## Department of Transportation

#### MEMORANDUM

**SUBJECT:** ZC Case No. 24-23 – 701 Howard Road SE (Cedar Tree Academy)

**Figure 1 | Site Plan**

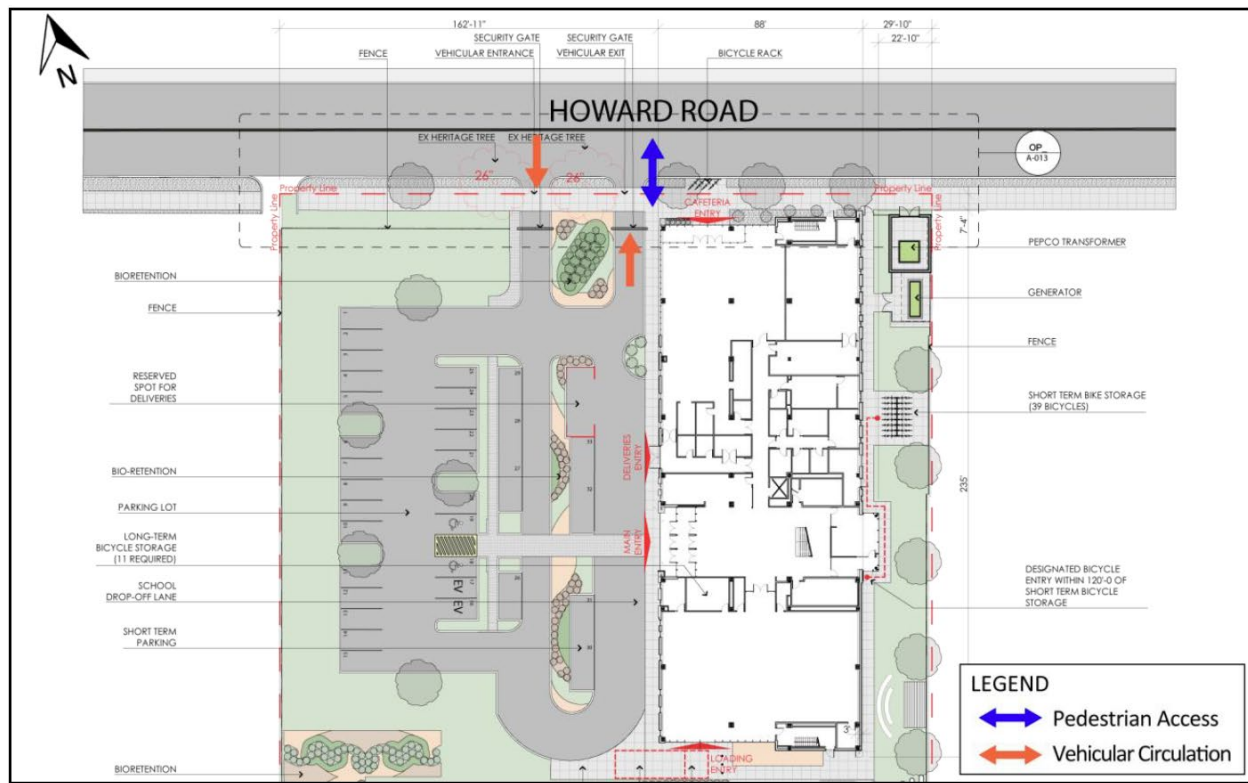
Pedestrian access to the school is proposed from both Howard Road SE and the school parking lot. Vehicle access to the parking lot and pick-up/drop-off area is proposed via direct access from Howard Road. The Applicant initially proposed providing access via two (2) one-way curb cuts, in the same locations as the two (2) existing curb cuts, to preserve two (2) Special Trees that had been designated to remain by UFD. However, UFD determined that the trees were no longer viable and no longer needed to be preserved. Therefore, DDOT strongly encourages the Applicant to consolidate access to a single two-way curb cut. Figure 1 below shows the site layout of the proposed project.

The building is designed so that all loading activities take place in the loading dock area. The truck turning diagrams included in the CTR demonstrate that, in the dual curb cut access scheme, 30-foot trucks are unable to enter the site from Howard Road SE with head-in and head-out movements, as required by DDOT standards. The Applicant should re-design their site access with a single two-way curb cut to accommodate these trucks.

DDOT strongly supports the Applicant’s proposal to upgrade the sidewalk along Howard Road along the site frontage to eight (8) feet wide with a planting strip buffer. While the preliminary public space plans, shown above in Figure 1, are generally consistent with DDOT standards, there are several considerations that need to be reviewed in greater detail during the public space permitting process:

- The Applicant should consolidate the site’s dual 12-foot curb cuts into a single 24-foot curb cut to allow enough space for large trucks to turn in and out of the site without running over the curb;
- All building entrances must be at grade with the sidewalk so that no stairs or ramps will be necessary in public space; and
- Submit a detailed curbside management plan with proposed signage for review and approval by DDOT Curbside Management Division (CMD). If CMD requires multi-space meters for the remainder of the frontage, they will be at the Applicant’s expense.

**Figure 2 | Existing Pedestrian Network**

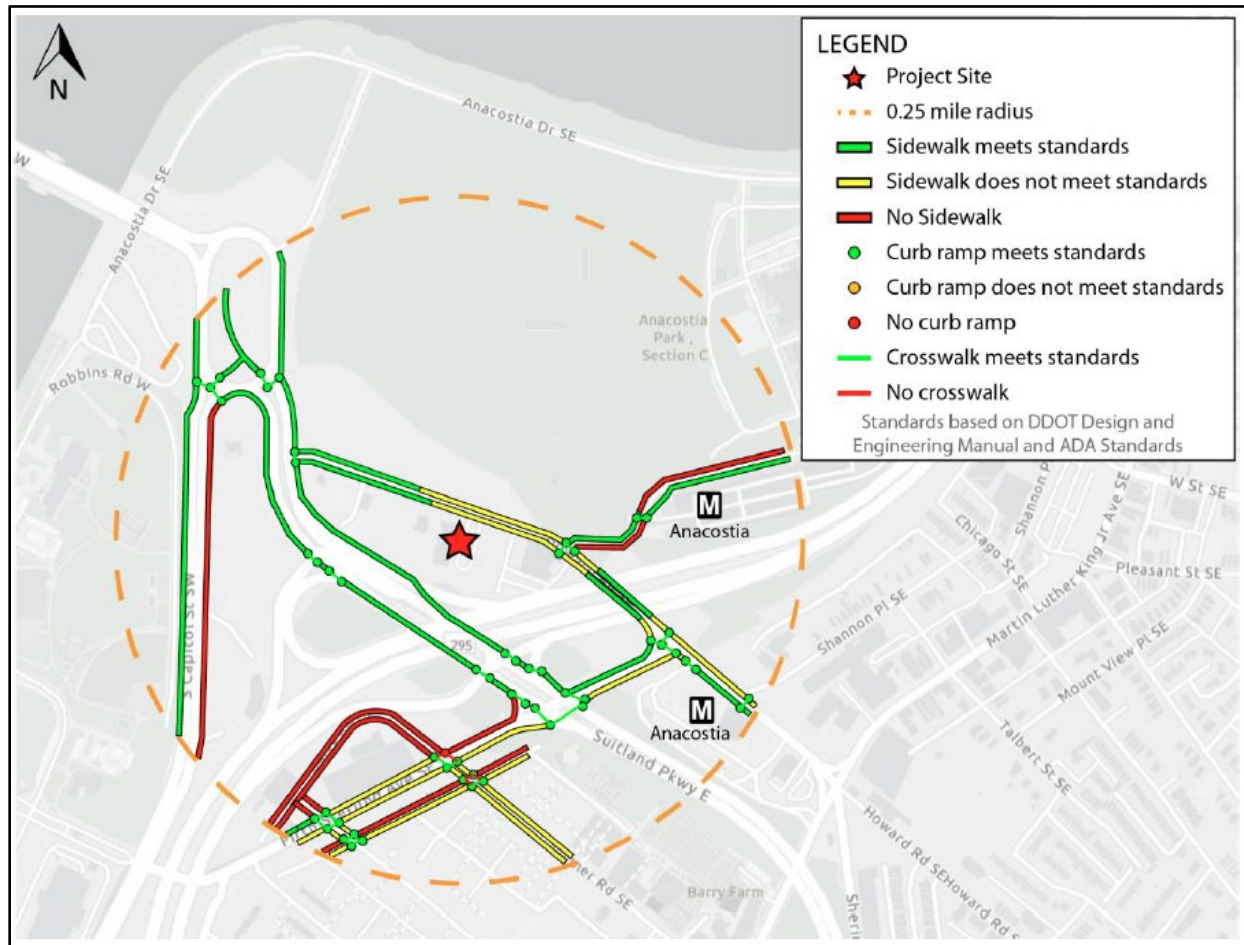
The CTR's inventory of existing pedestrian infrastructure, as shown in Figure 2 below, demonstrates that some sidewalks in the immediate vicinity of the site have appropriate widths and include accessible curb ramps. While there are several missing or substandard facilities in the broader area, the existing pedestrian network along major walking routes from the site to schools, attractions, and the Metrorail station is generally adequate. The Applicant will also upgrade the sidewalk on Howard Road along the site frontage to DDOT standards with an eight-foot sidewalk and landscaped buffer.

**Figure 3 | Existing Bicycle Facilities**

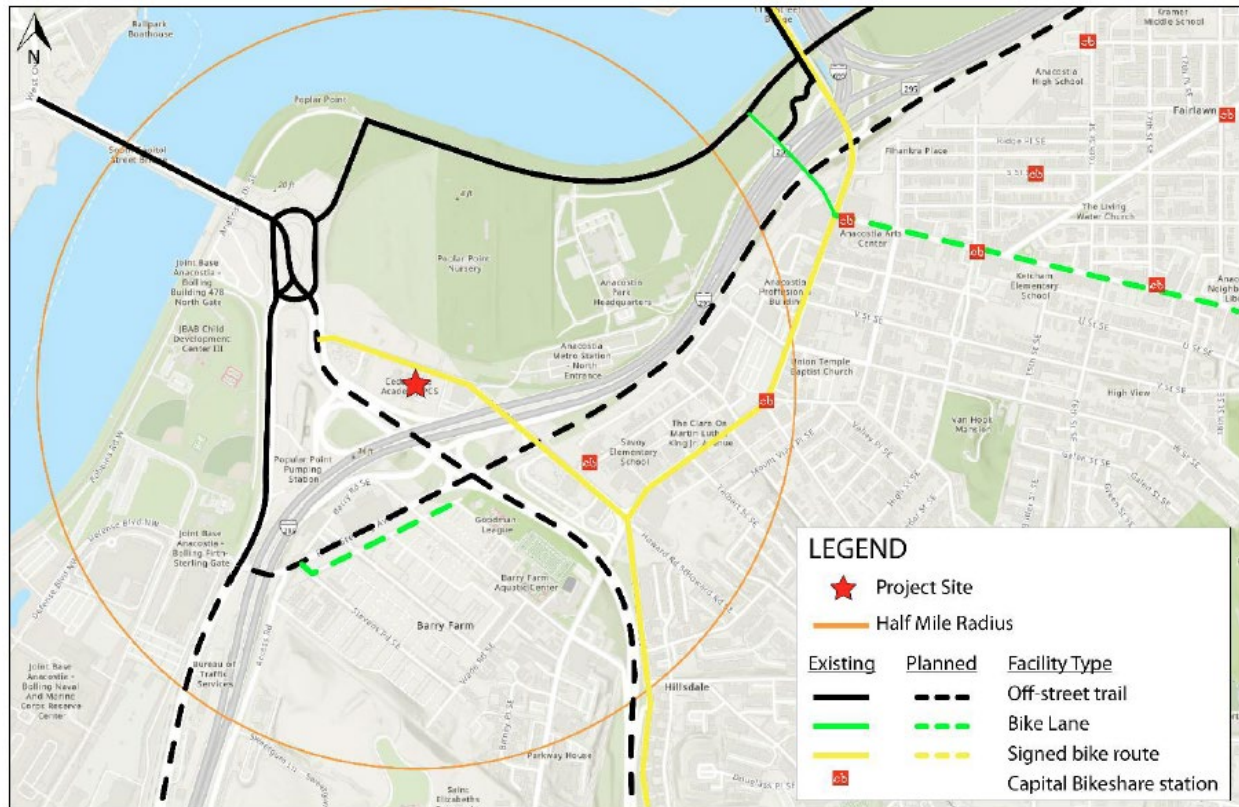
As shown below in Figure 3, there are several existing and planned bicycle facilities near the site. Currently, staff and students can reach the school site by bicycle from the South Capitol Street Trail, Suitland Parkway Trail, and Anacostia Riverwalk Trail via the signed bike route along Howard Road SE. In the future, the Shepherd Branch Trail, the southward expansion of the Suitland Parkway Trail, and the Firth Sterling Avenue SE protected bike lane will provide bicycle access to the school. The closest Capital Bikeshare station to the site is located at the southern entrance to the Anacostia Metrorail Station. Per ZC Order No. 22-39, the Bridge District developer is required to fund and install a 23-dock Capital Bikeshare station in a nearby location along Howard Road.
